CONSERVATION COMMISSION AGENDA

The Conservation Commission will hold this meeting as a virtual meeting on Thursday, November 19, 2020 at 7:00 pm. No in-person meeting will take place at City Hall.

1. **Zoning Redesign – Community Engagement Update Presentation**
 - **Presenter:** Nevena Pilipovic-Wengler, Community Planning/Engagement Specialist
2. **1000 Commonwealth Avenue (City Hall Ponds) – OOC – pond dredging – DEP File #239-878**

ACCESS + DREDGING LAGOON PLAN EASTMAN C-100

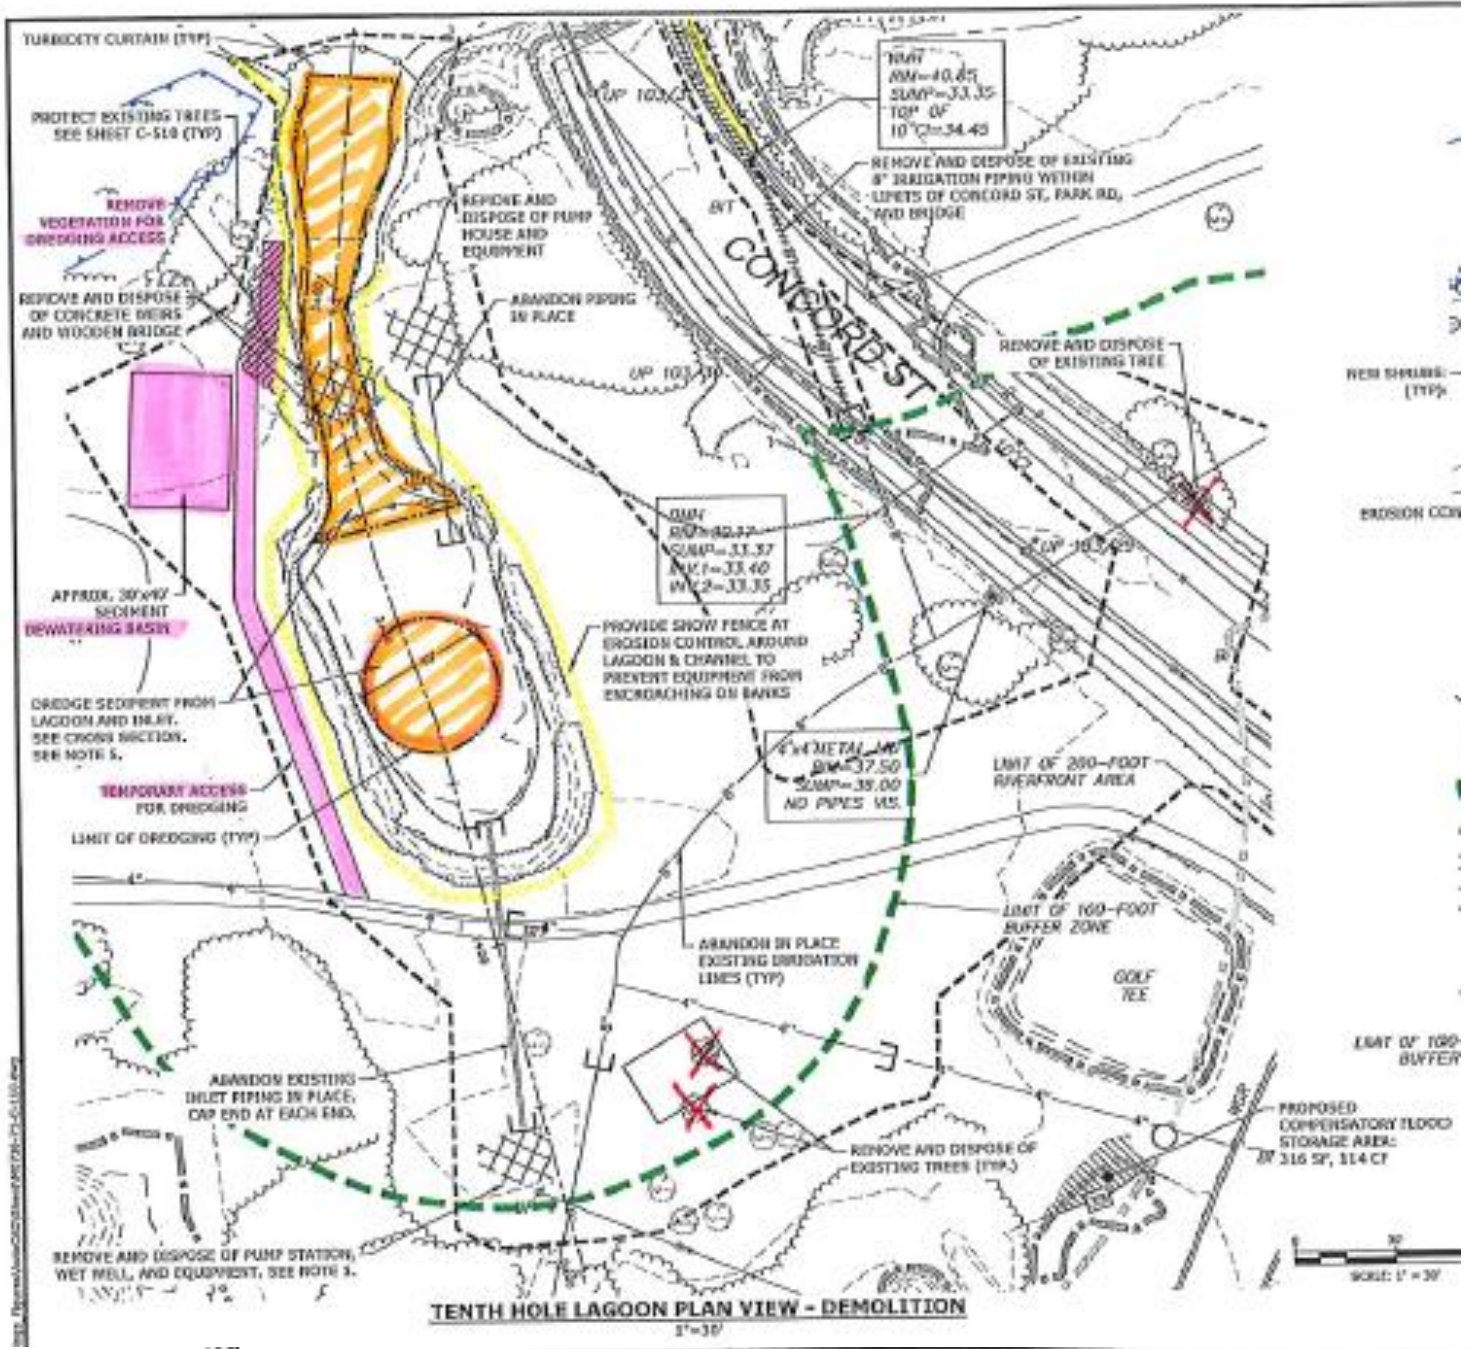
- Dredging access will be from the south side for less disturbance.
 - Plantings have been revised to include 52 trees and 47 shrubs.
 - Applicant should correct Sheet C-105, which shows the wrong trees as to be removed.

SITE PLANTING PLAN @ 110 A.

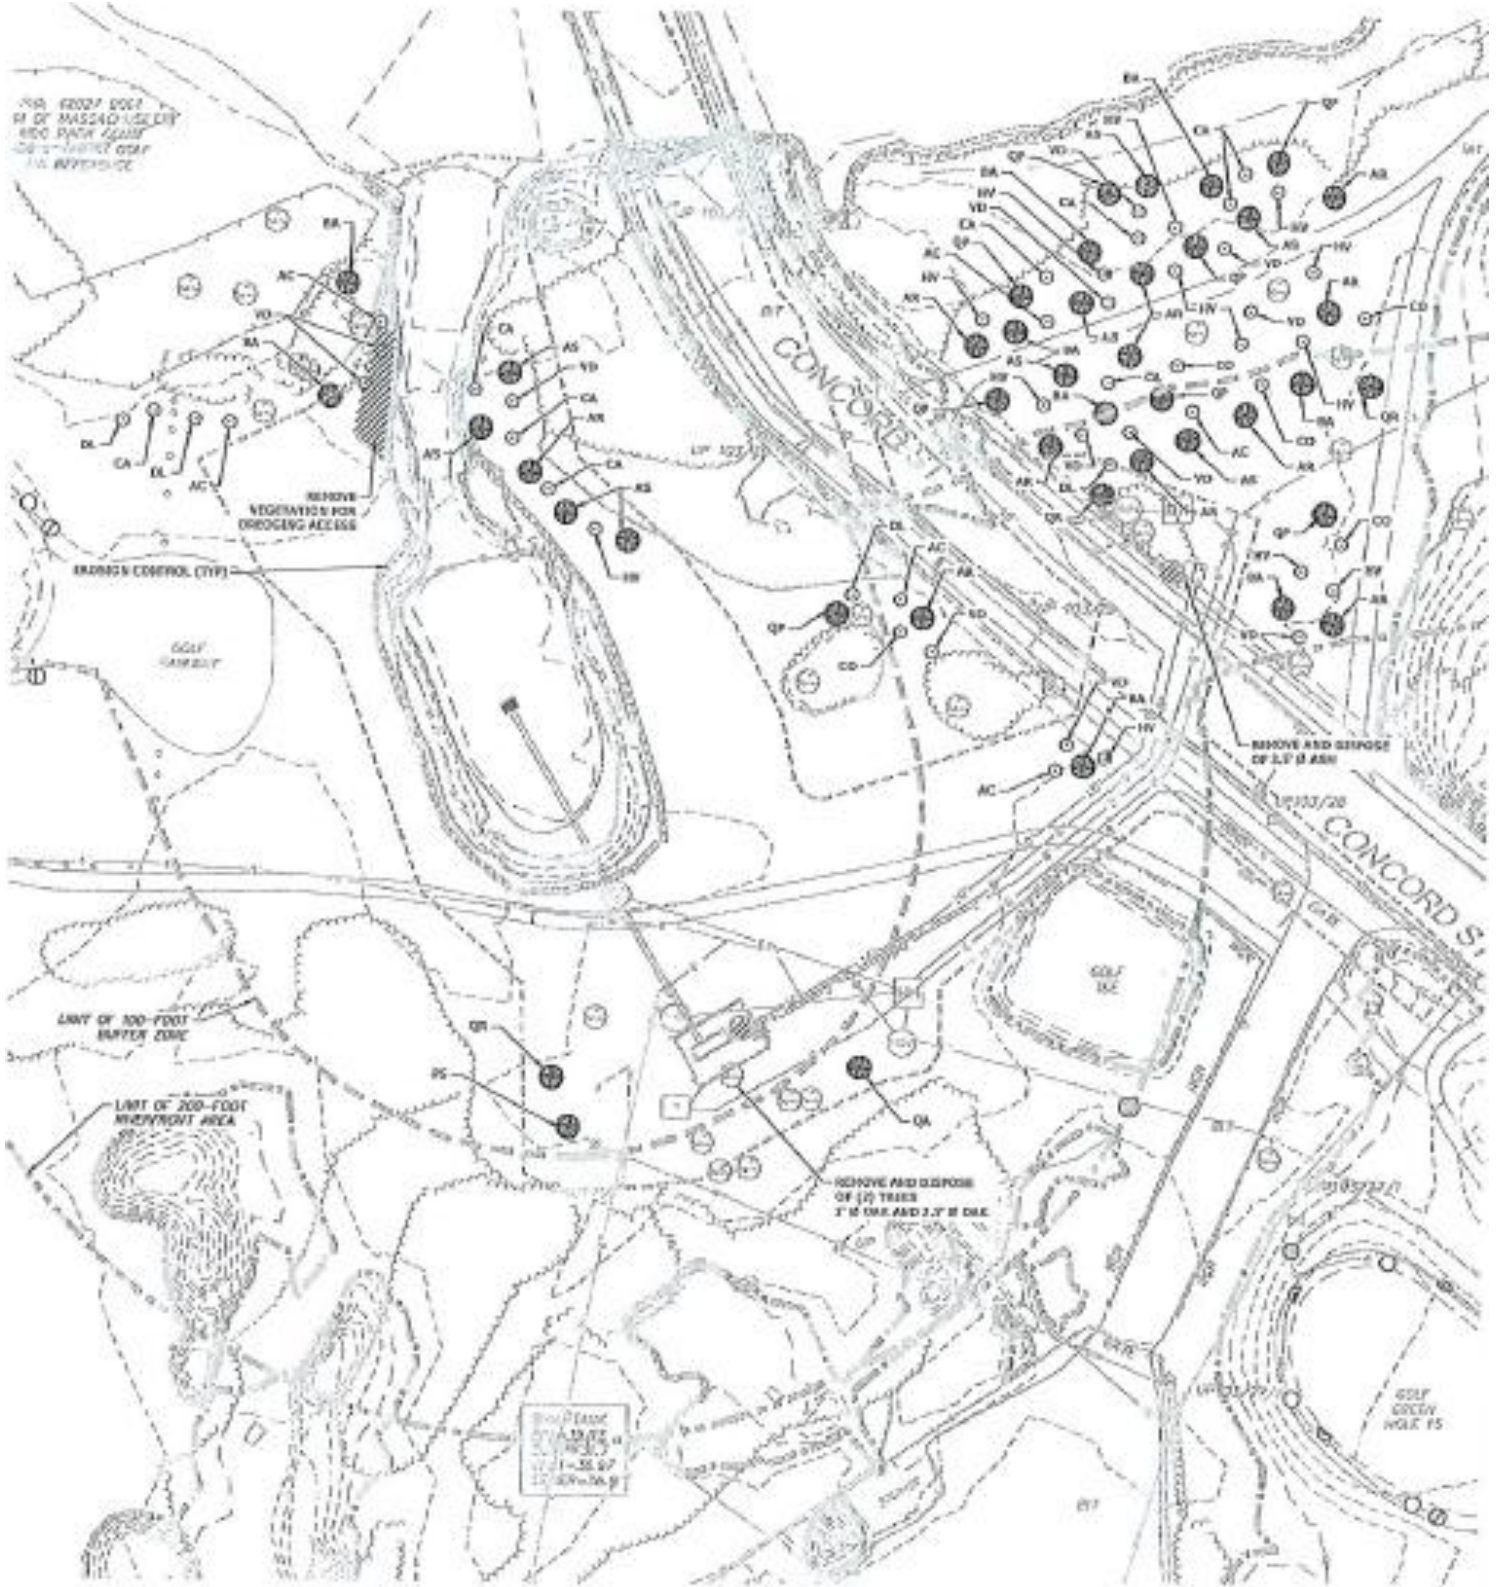
- Applicant should clarify where on Sheet C-109 and C-110 where erosion controls and snow fencing will be installed.
 - Staff counted 47, not 49, shrubs on Sheet C-110A.

42 trees > in RFA
 47 shrubs

PROPOSED INSTALLATION PLAN

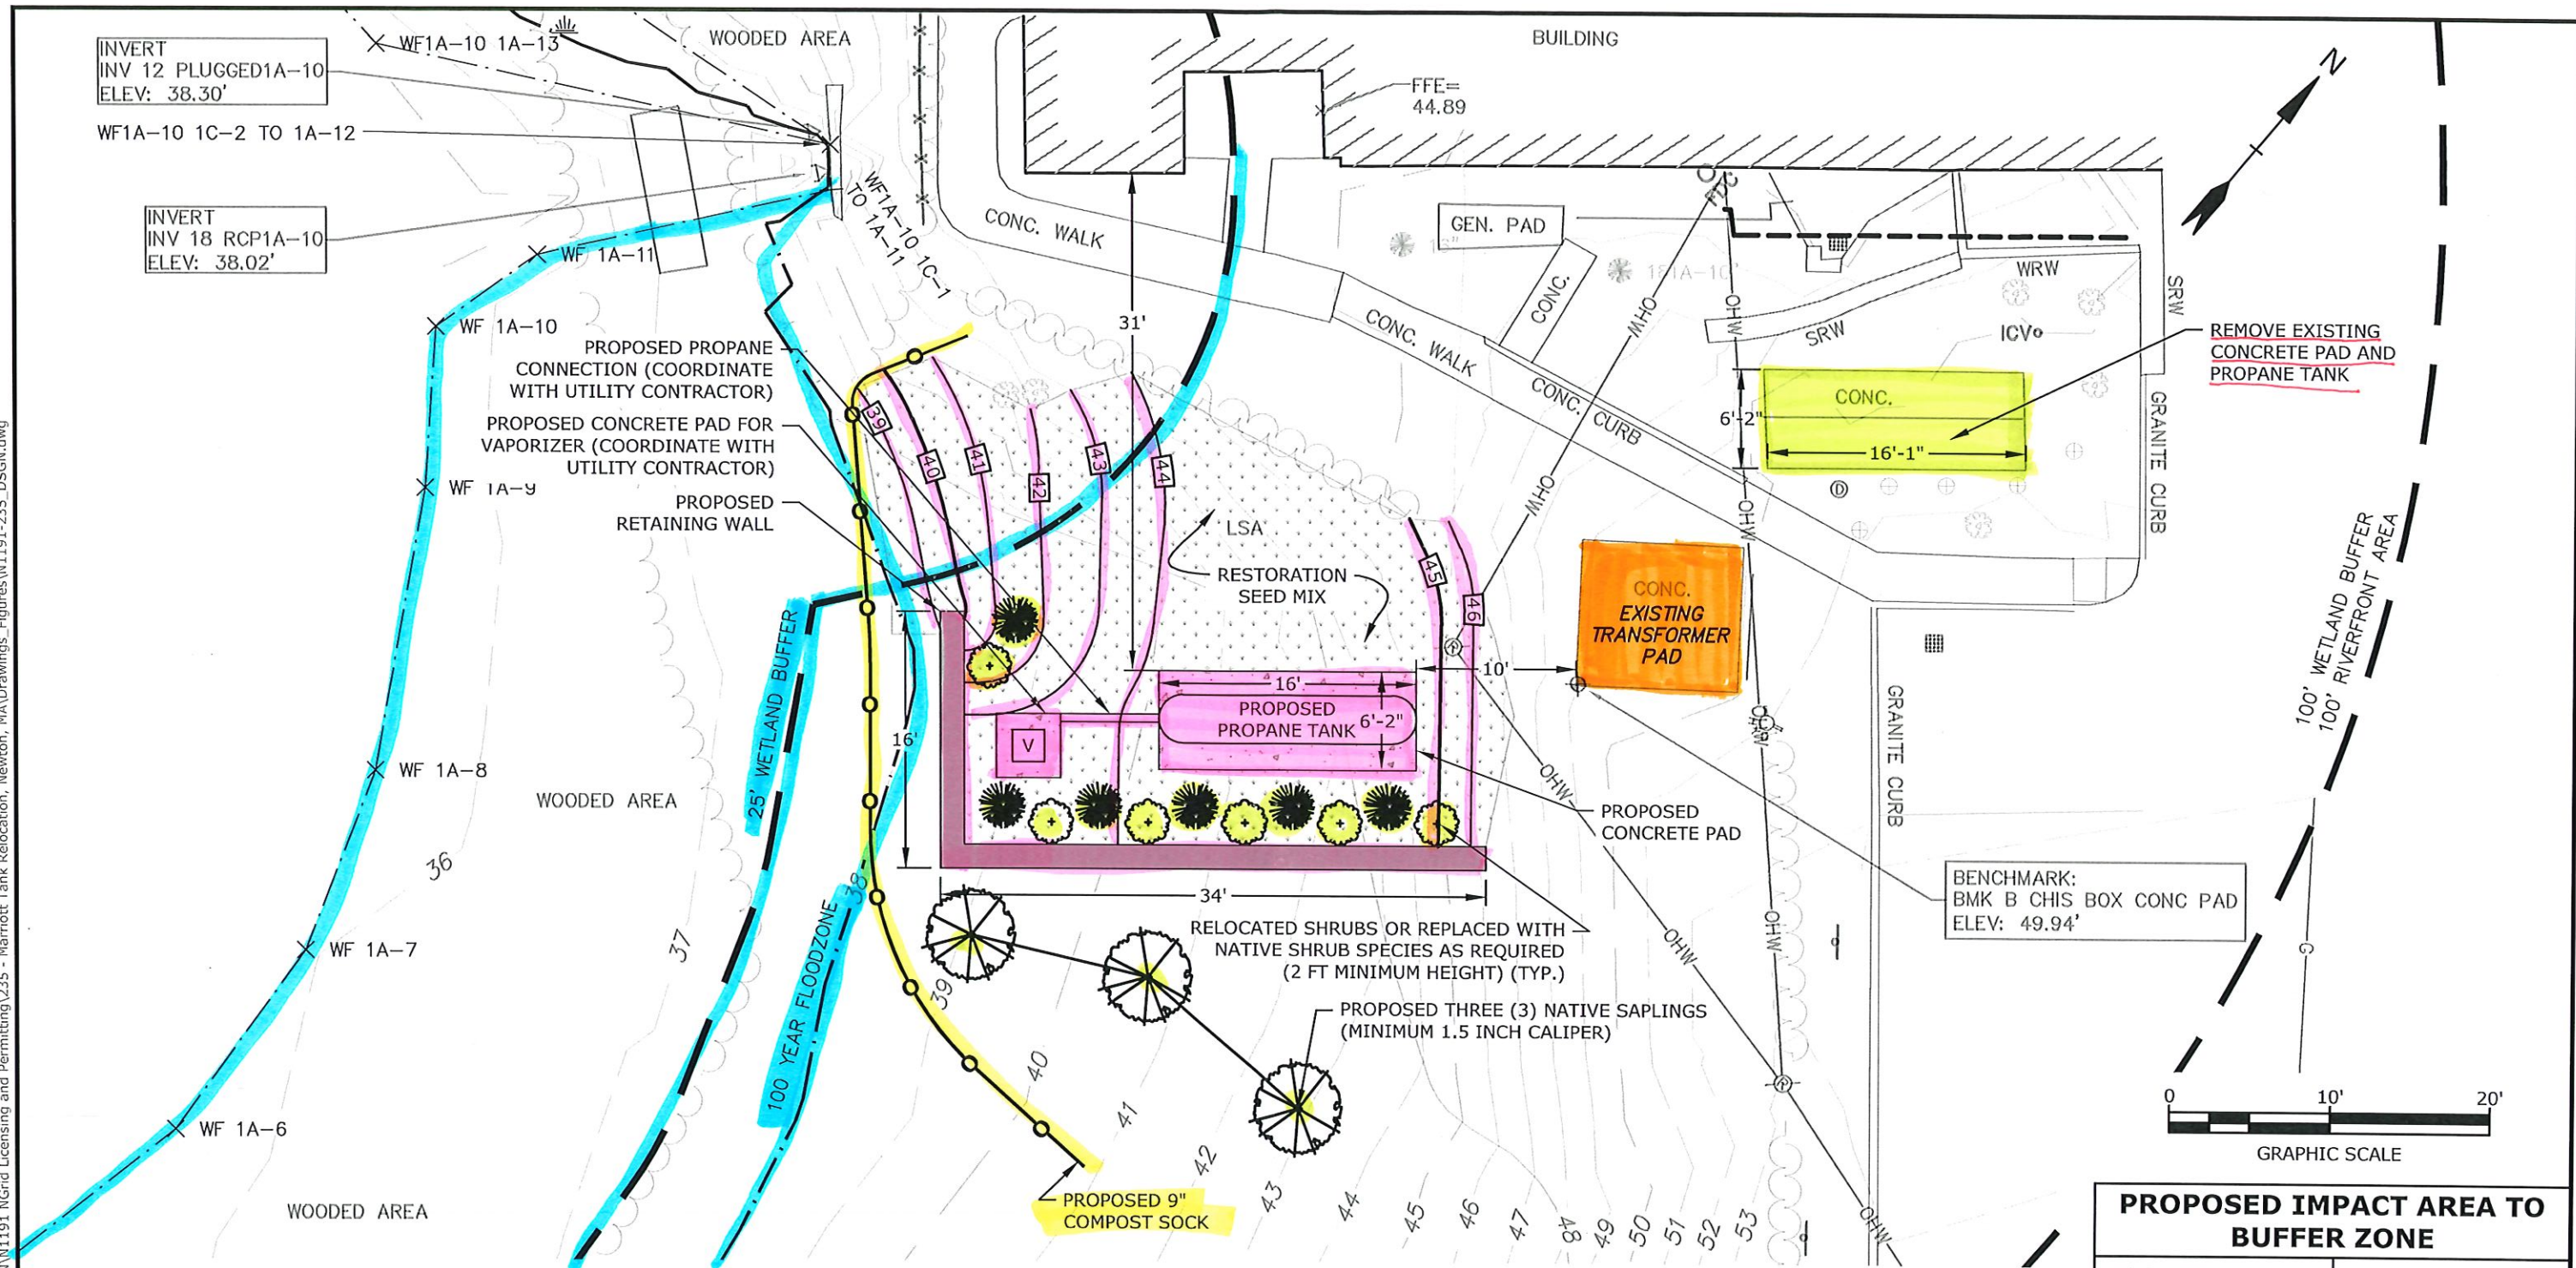
- Staff Notes:
 - The largest impact change in the requested amendment is a larger area of regrading for the new equipment location, versus the previous location adjacent to the building.

- The regrading does impinge on the 25' buffer but will not result in the removal of natural woody vegetation, only the regrading of lawn and mulch bed. Disturbed areas within the 25' buffer zone are proposed to be reseeded with the New England Wetland Plants Erosion/Restoration Mix for Dry Sites.

- All other proposed plantings remain the same.
 - Applicant should propose winter slope stabilization plans, as seeding may not be accomplished in the growing season.
